City of Portland, Maine – Building or Use Permit Application 389 Congress Street, 04101, Tel: (207) 874-8703, FAX: 874-8716

Re: Exterior Alterations; 103 Brackett Street. Window replacement, siding/trim restorations, fire escape/ deck structure, site improvements.

TO: Chair Wroth and Members of the Historic Preservation Committee
FROM: William B. Needelman, Planner
DATE: January 28, 1999
RE: February 3, 1999 - New Business

BUILDING PERMIT REPORT

ORIGINAL STAIRCASE IN Apt # 4 FROM EXISTING LIVING ROOM TO UPPER BEDROOM AND BATH

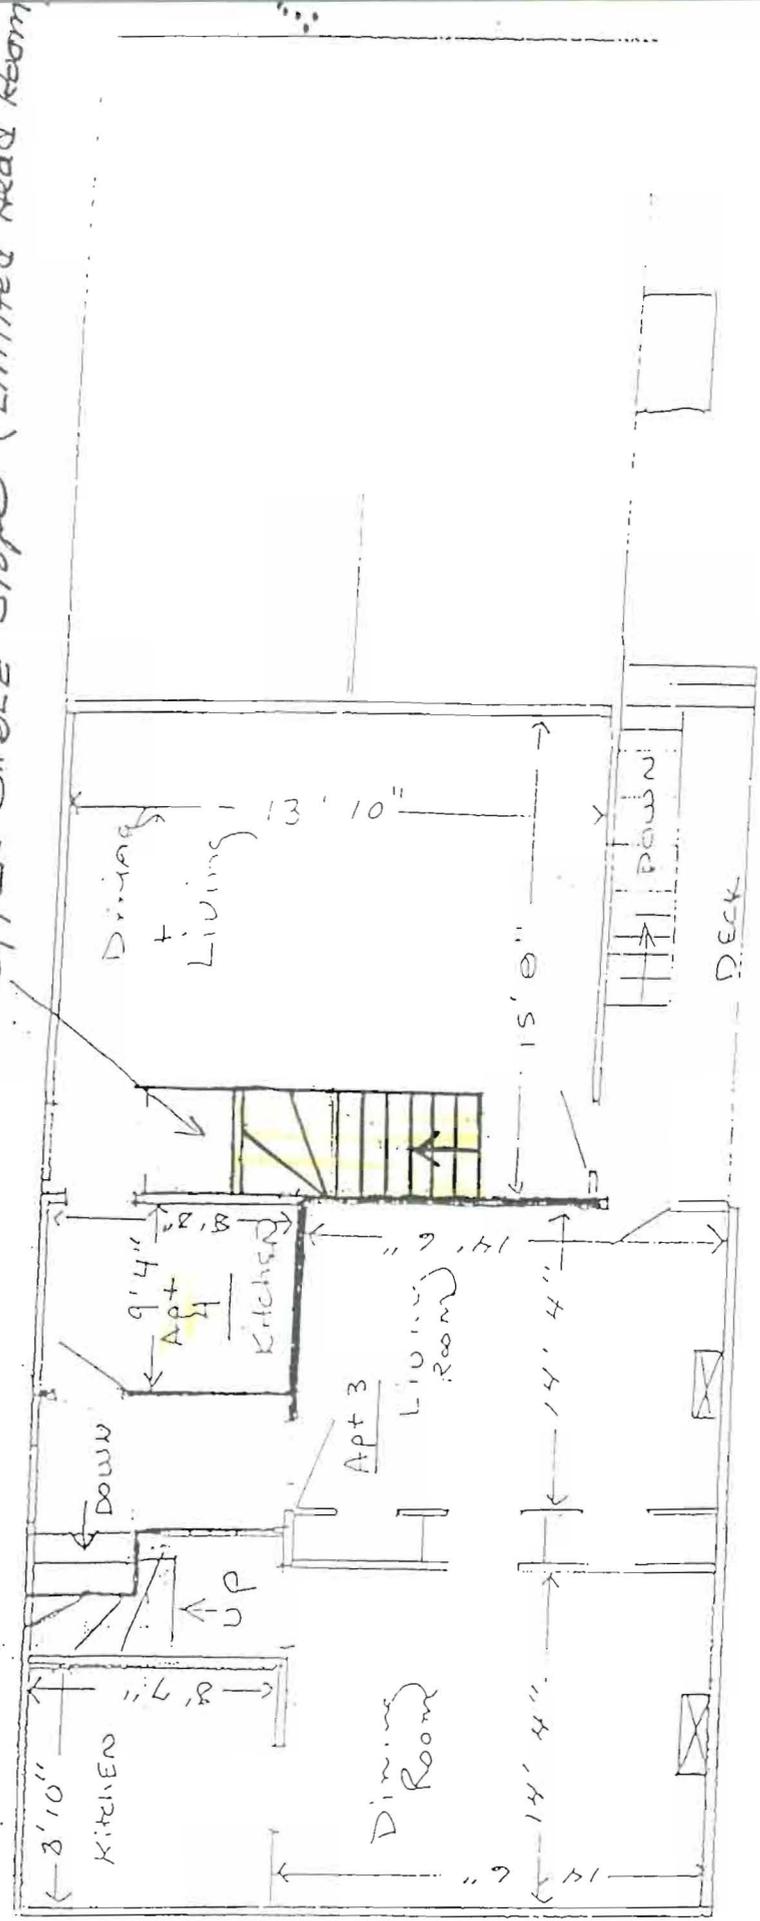
5-18-99 Lou Fourimer called for a R.I. on Plumbing had water test on OK on test, I talked to Mr. Crouther about the stairs on the 2nd to 3rd floor being 8 1/8 R. and 9" T. Told him to contact Sam about waver and to Recut carriage because of over cut at the throat of several stair points. (TR)
200 High St office

- ~~*9.~~ Headroom in habitable space is a minimum of 7'6". (Section 1204.0)
- ~~*10.~~ Stair construction in Use Group R-3 & R-4 is a minimum of 10" tread and 7 3/4" maximum rise. All other Use group minimum 11" tread, 7" maximum rise. (Section 1014.0)

PROPOSED NEW access and Decking
From ground level to 2nd level. Existing stairway to
3rd level on the interior to be used.

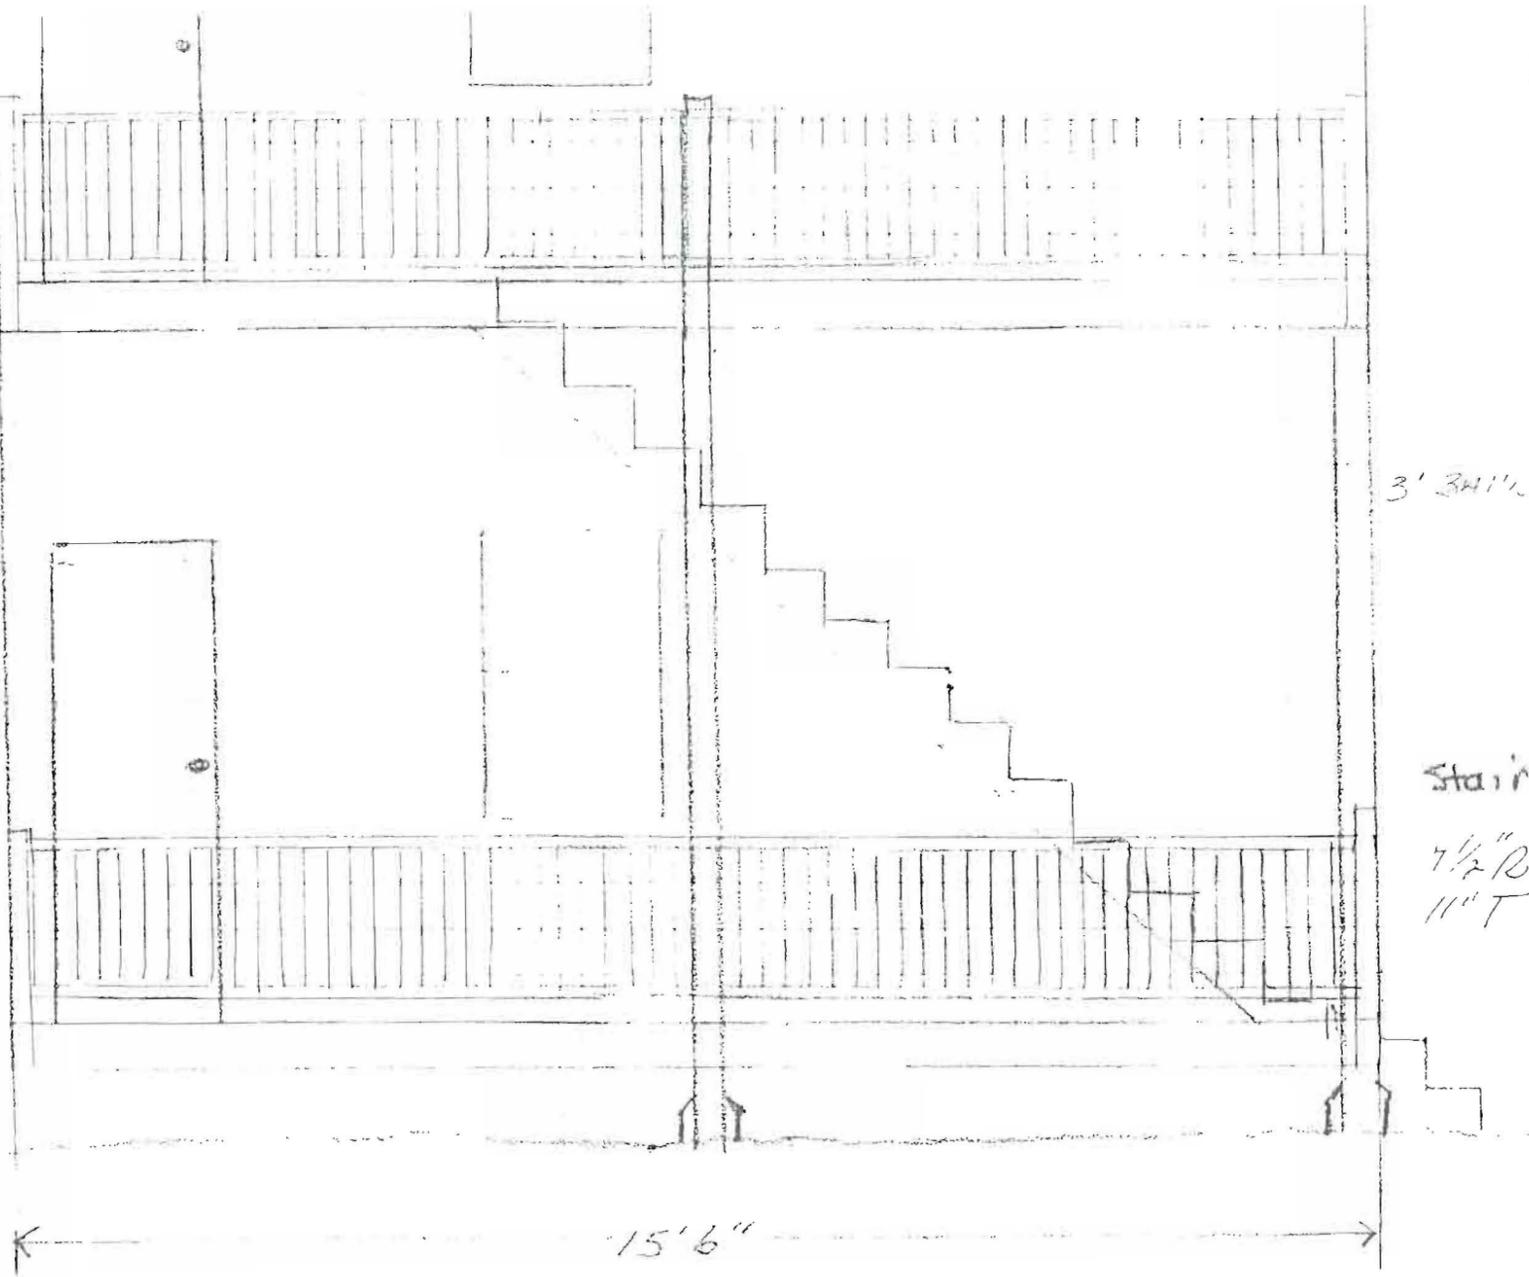
On February 3, 1999, the City of Portland's Historic Preservation Committee voted 5-0 (Breggia, Romano absent) to approve your application for a Certificate of Appropriateness, with conditions. The Committee granted approval with out conditions for your deck structure and site work (fence and parking.)

Proposed Roof over
 New Deck area
All Pressure Treated
 pitch 12"/4"

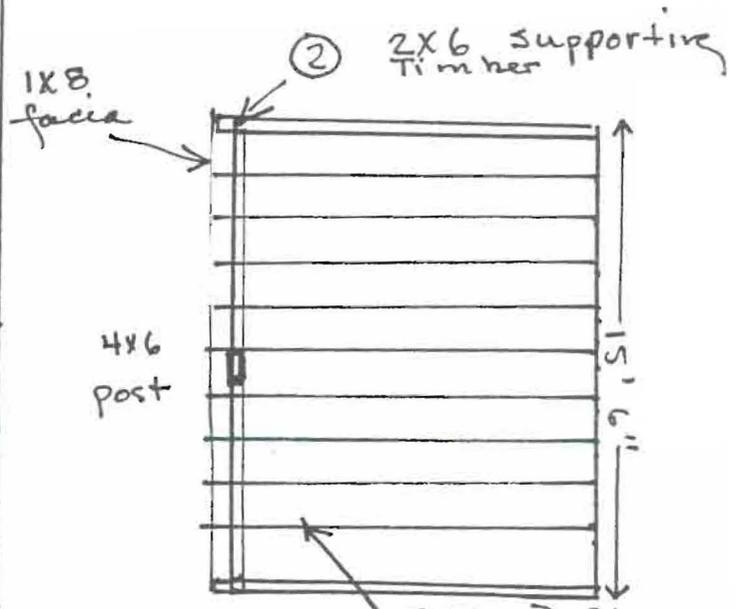
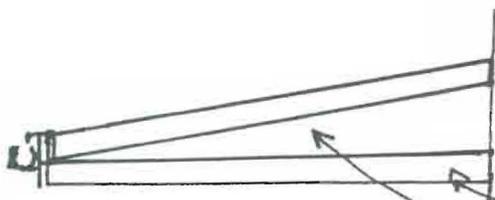
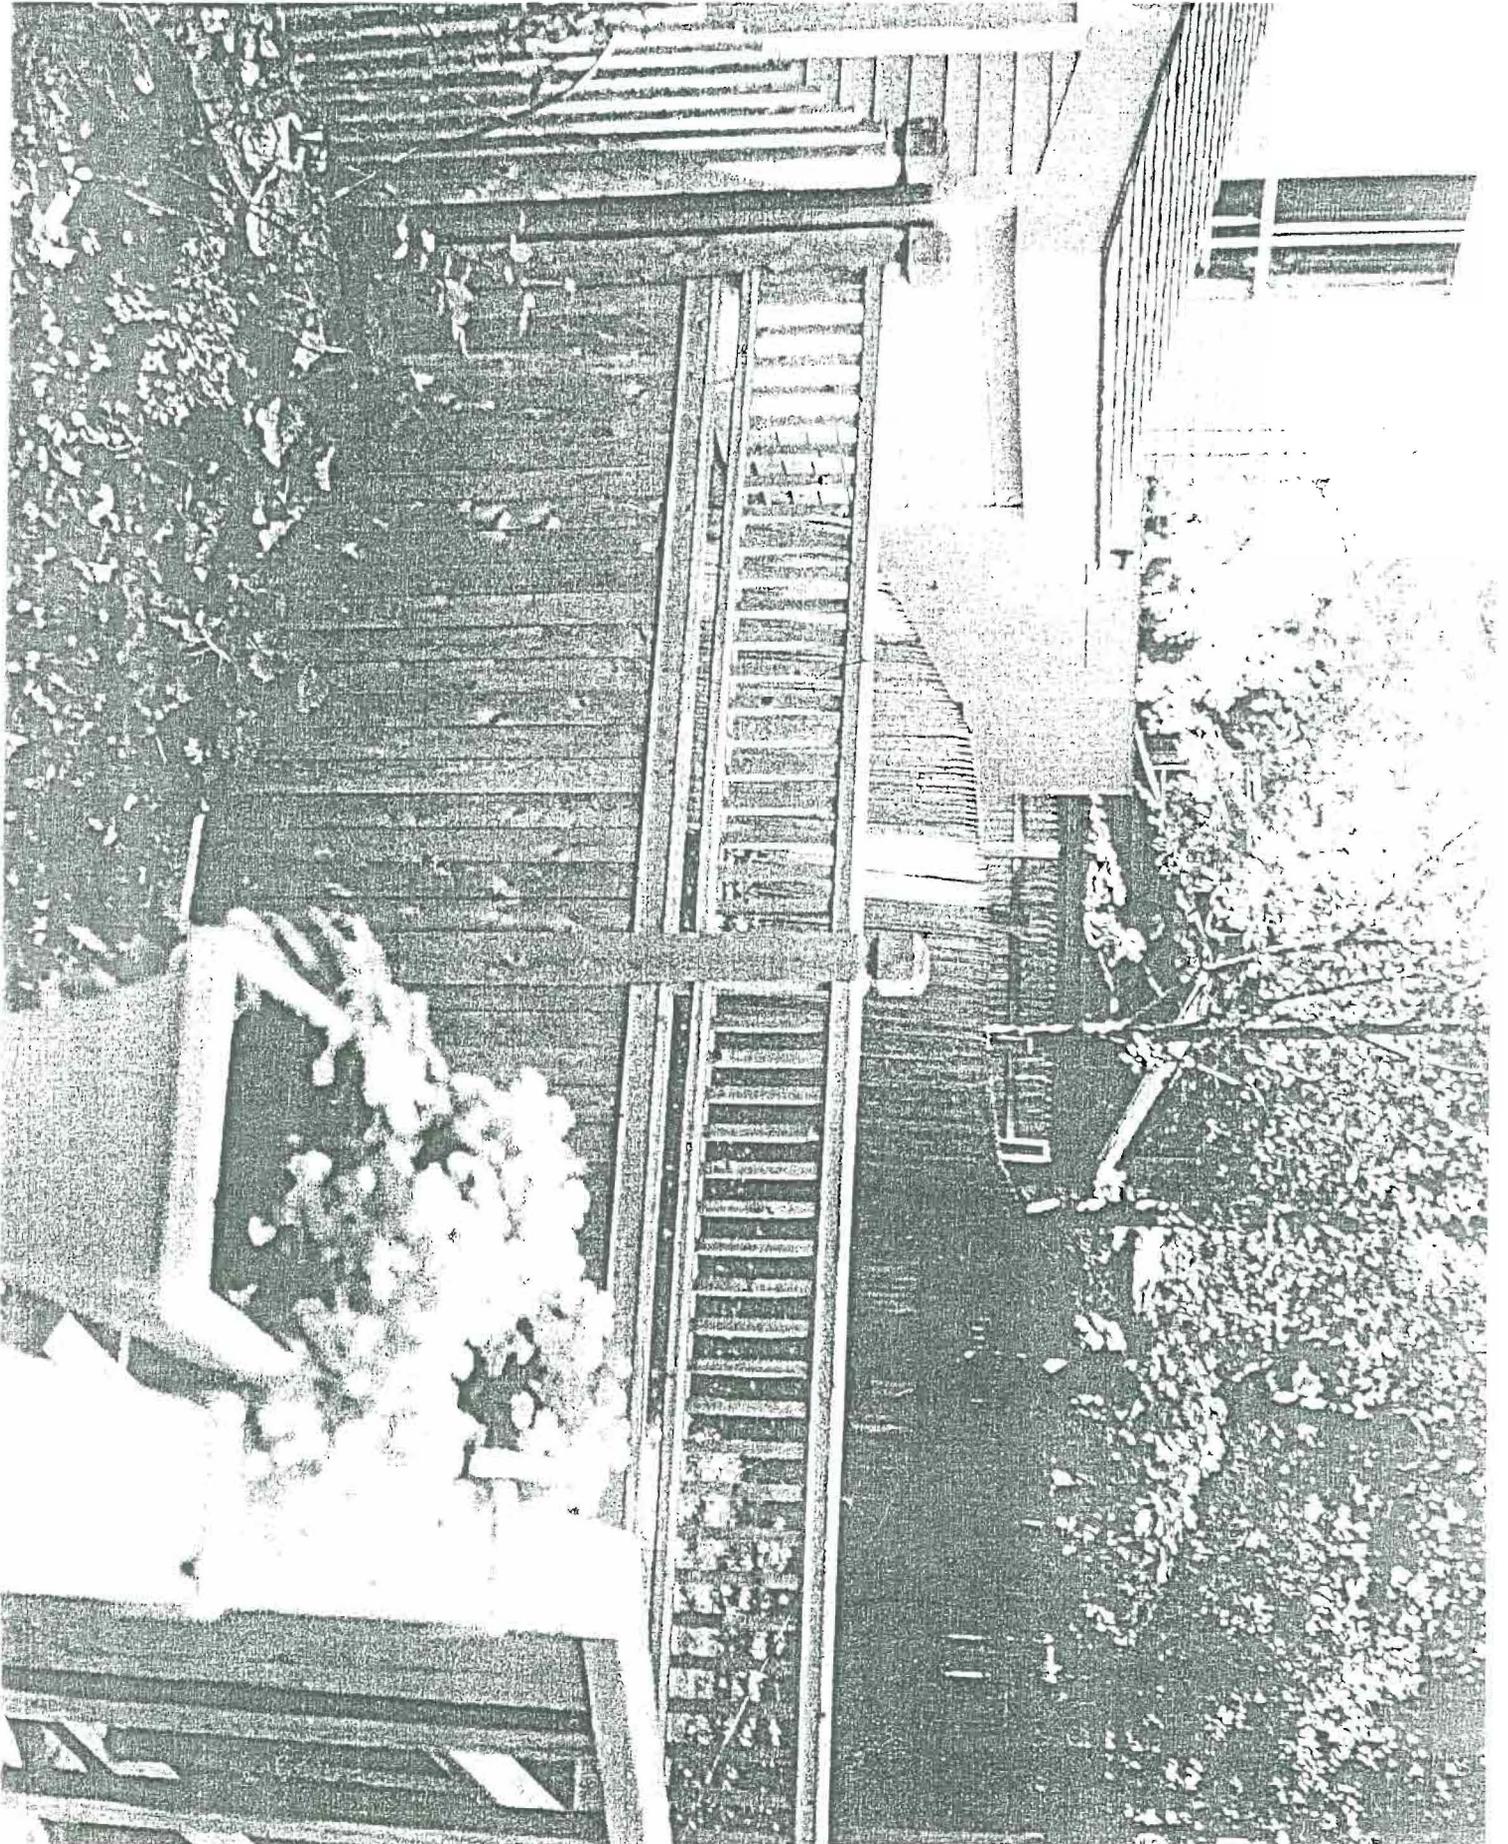
- i. That gutters of a style to be approved by Historic Preservation staff be installed in place of the 1x3 trim boards at the fascia of the roof modifications.
- ii. That the gutter to be installed on the lower roof be no larger than a standard 3-4 cross section and that the gutter will be recessed from the southerly face of the original structure
